# 42 Honeysuckle Drive

State Significant Development (SSD-10378)

DEVELOPMENT MODIFICATIONS

March 2022

# 4.1 Design Changes

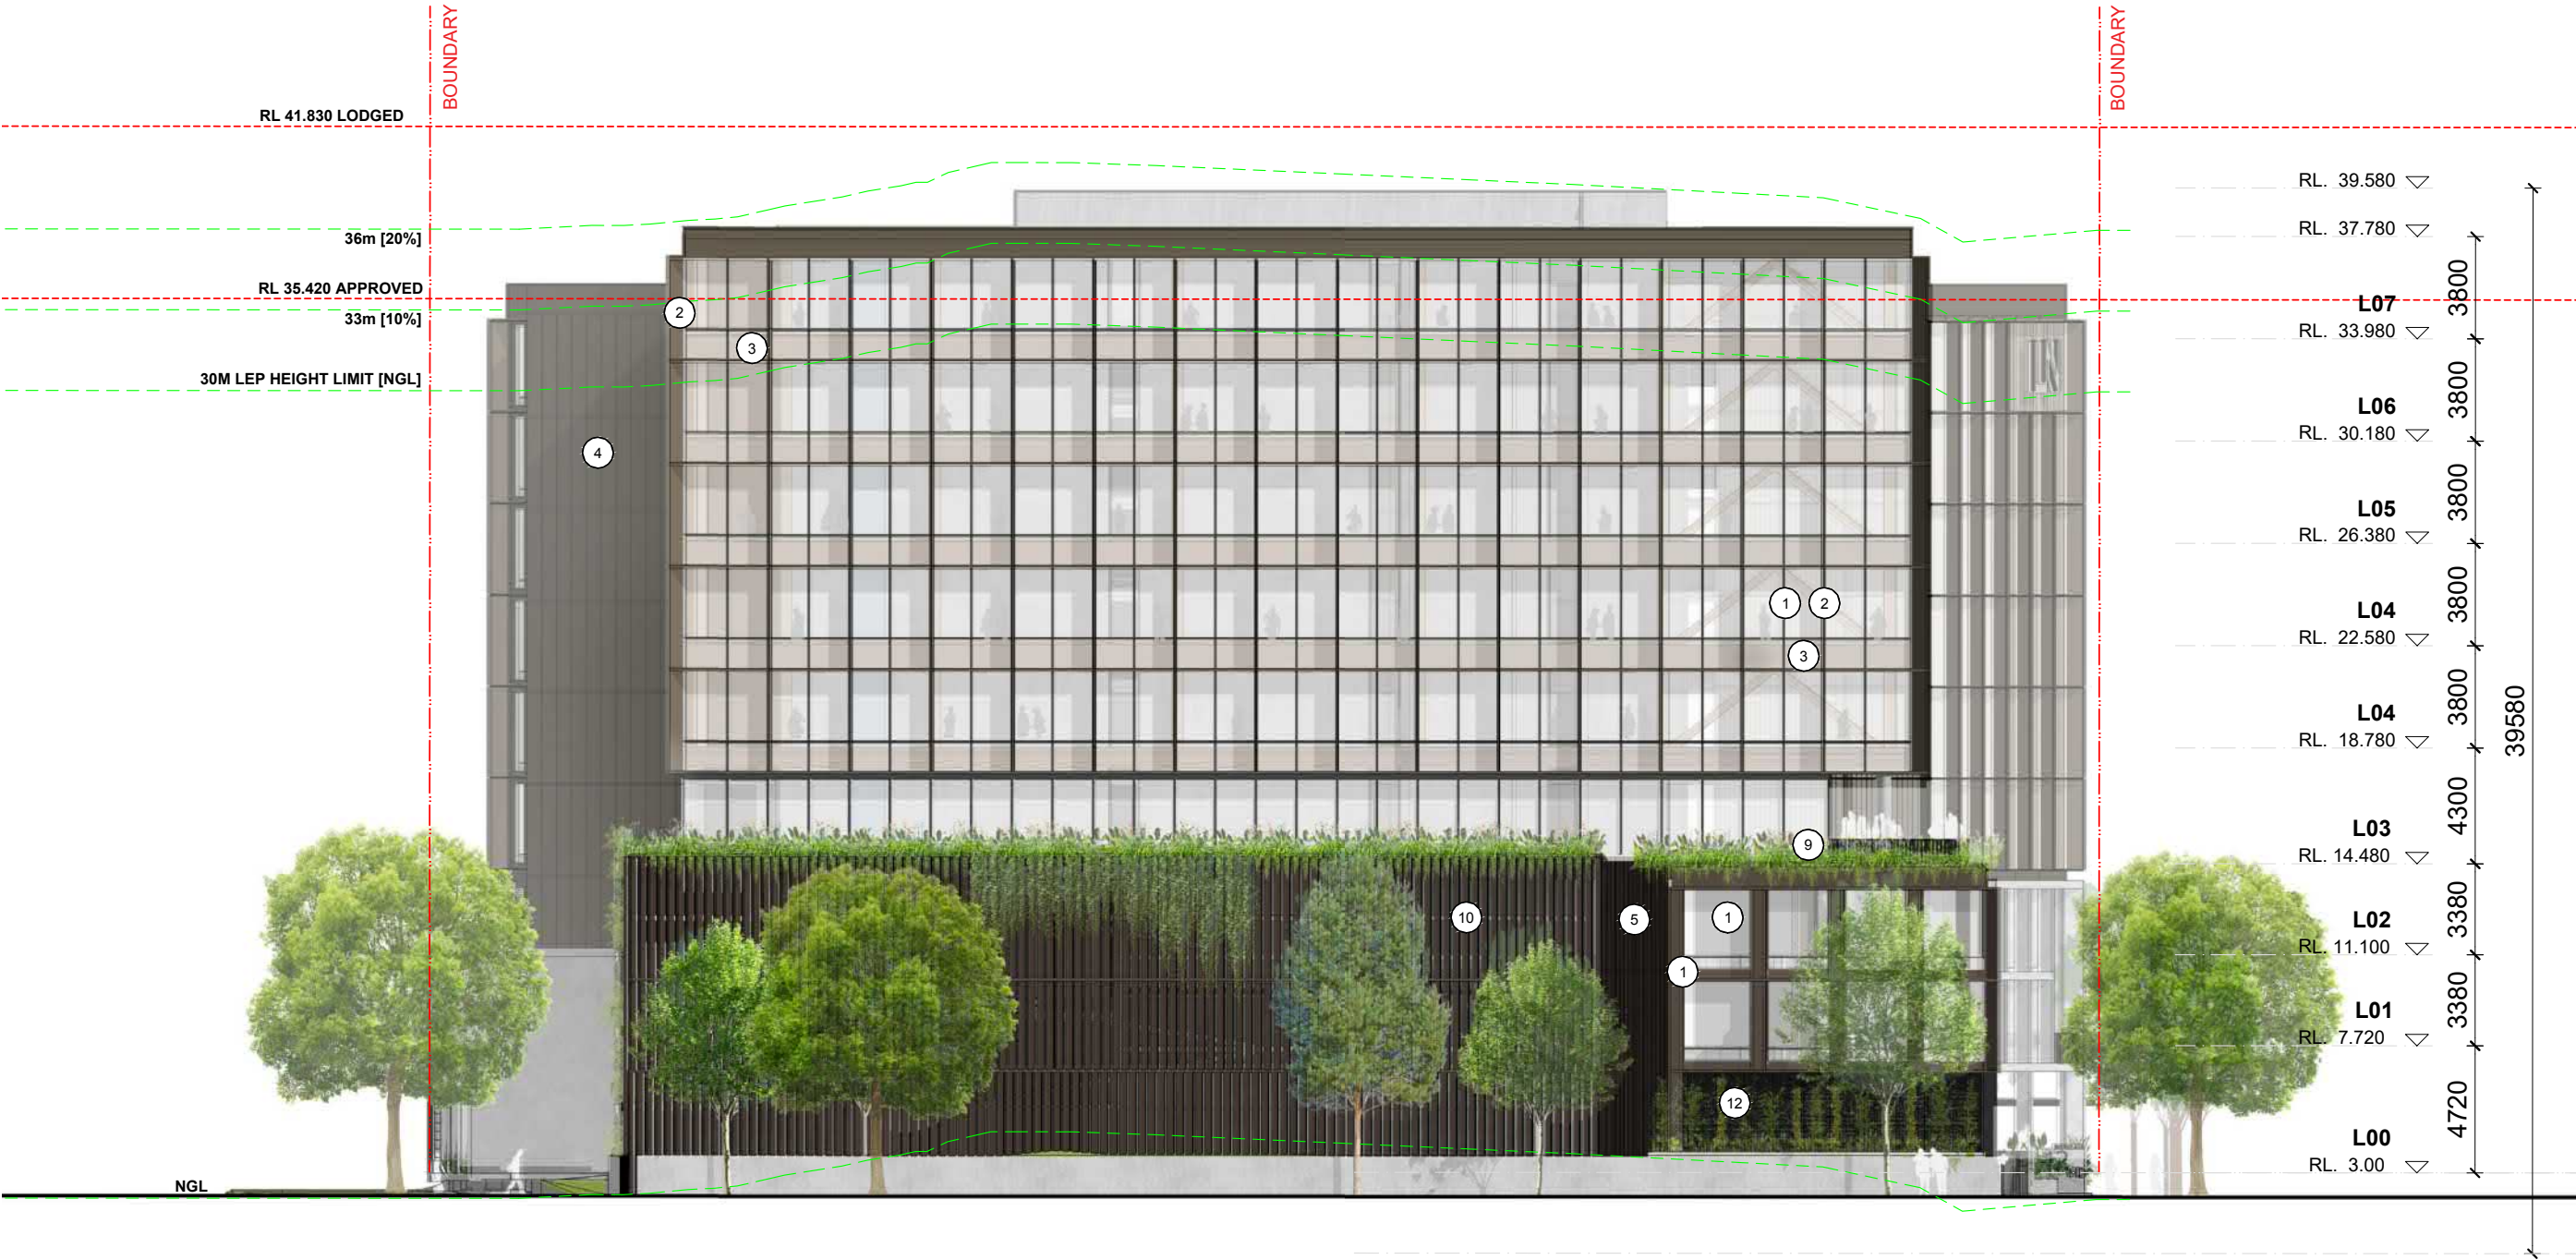
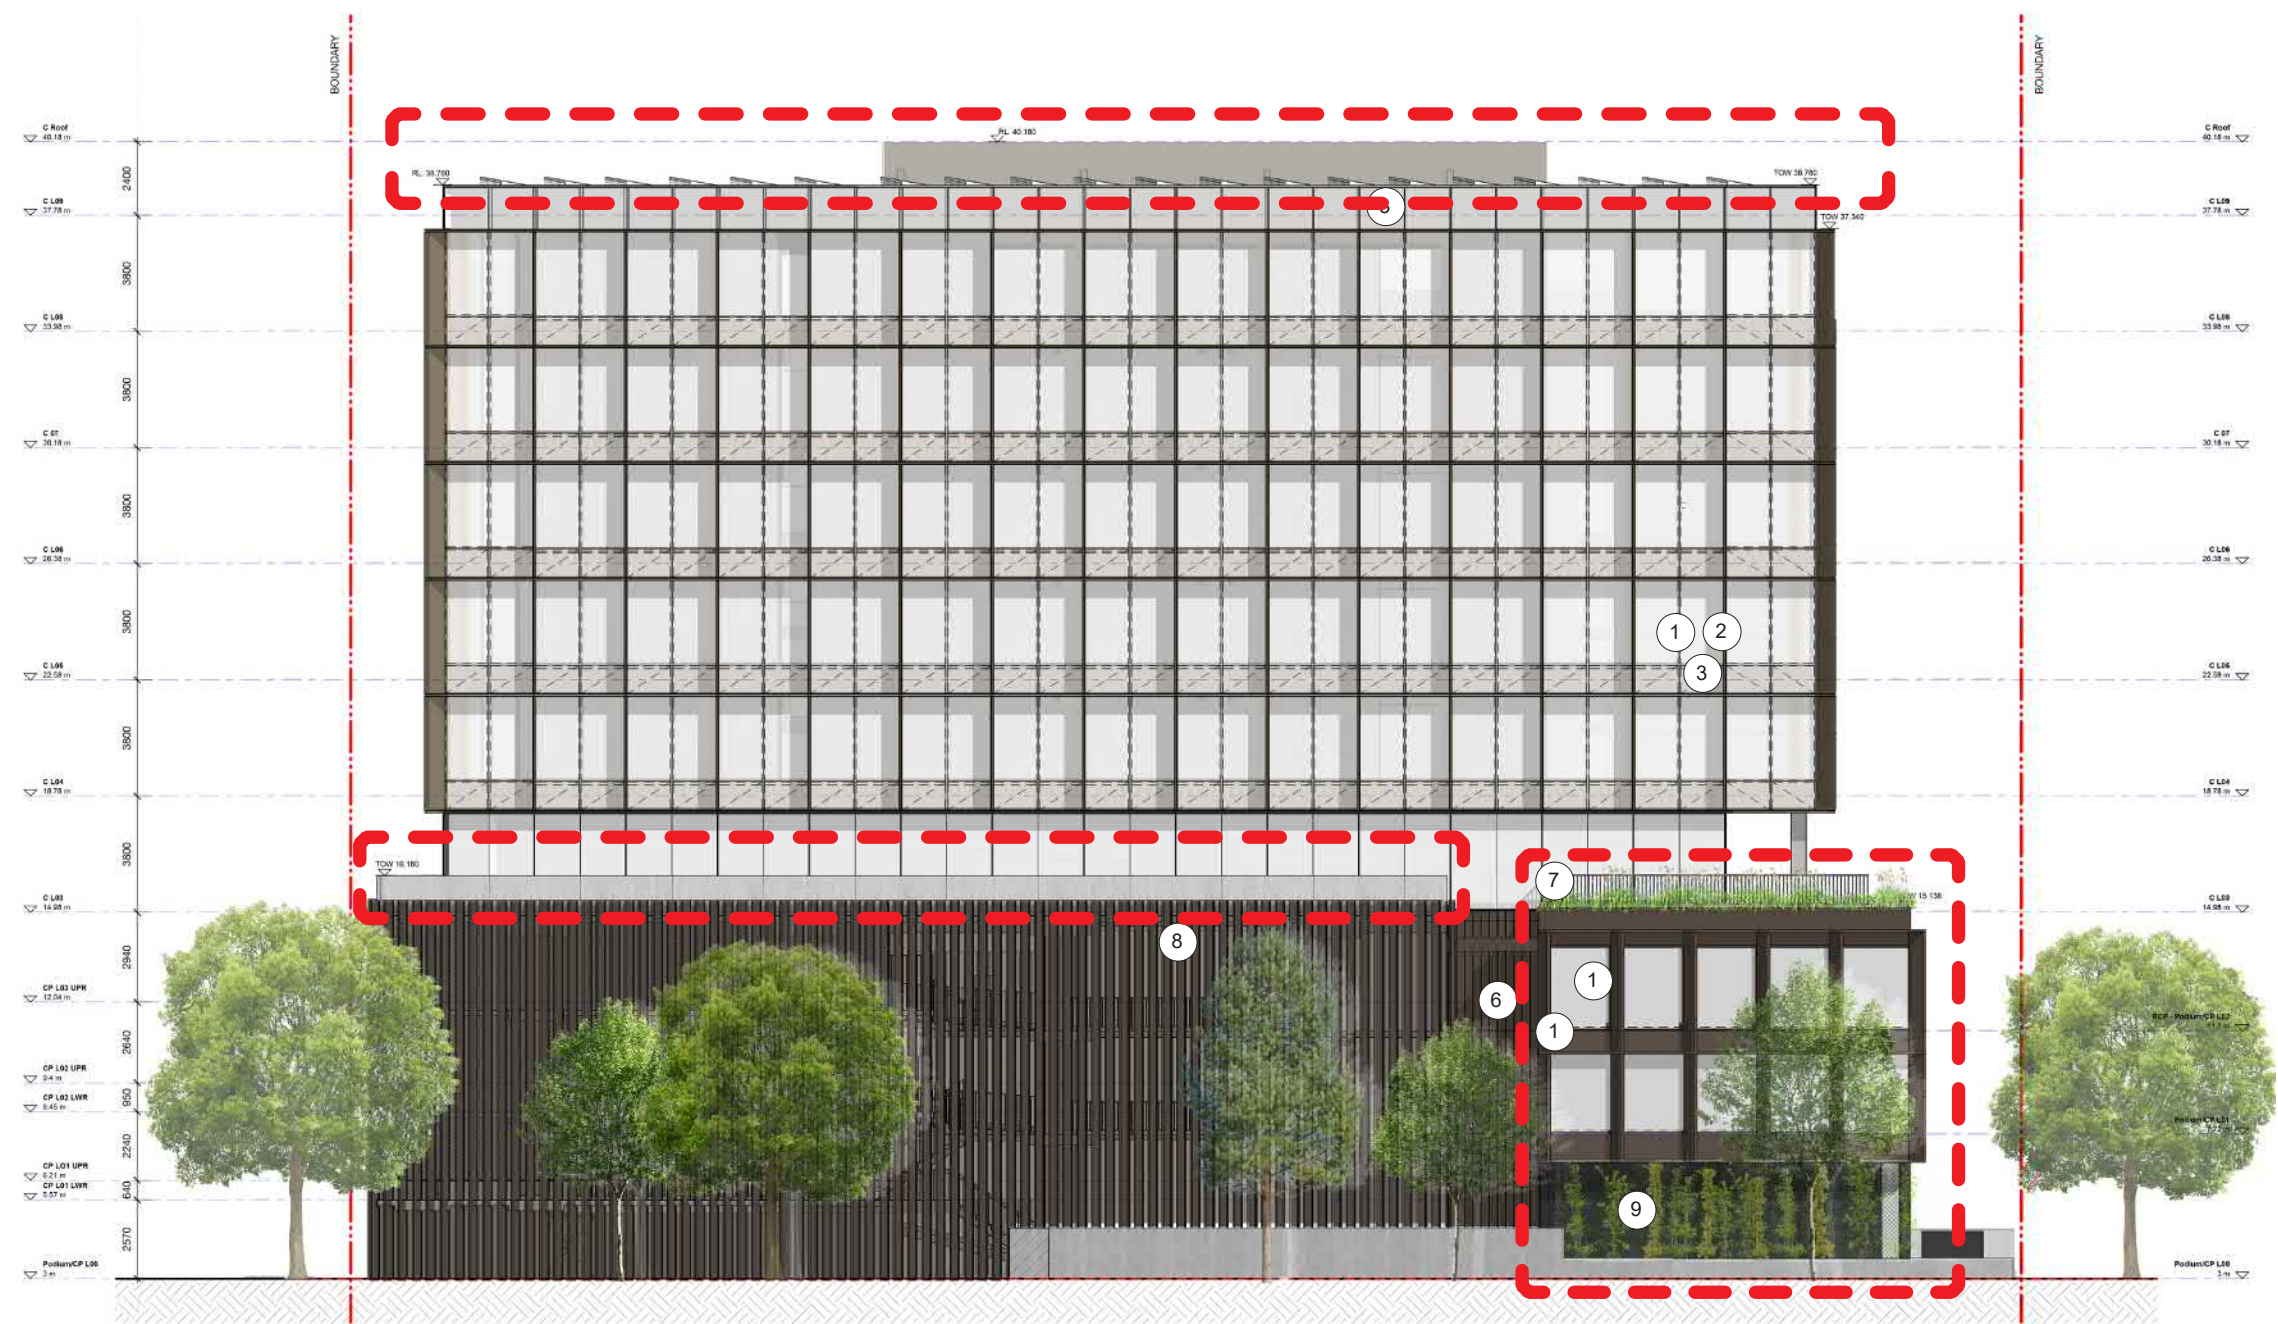
- 1 / Commercial podium levels L01 and L02 facade amended with a singular vertical sunshade expression
- 2 / Commercial tower height increased by 600mm to allow for additional plant height.
- 3 / Perimeter edge planters to Level L03 over carpark omitted
- 4/ Facade colours and materiality remain the same
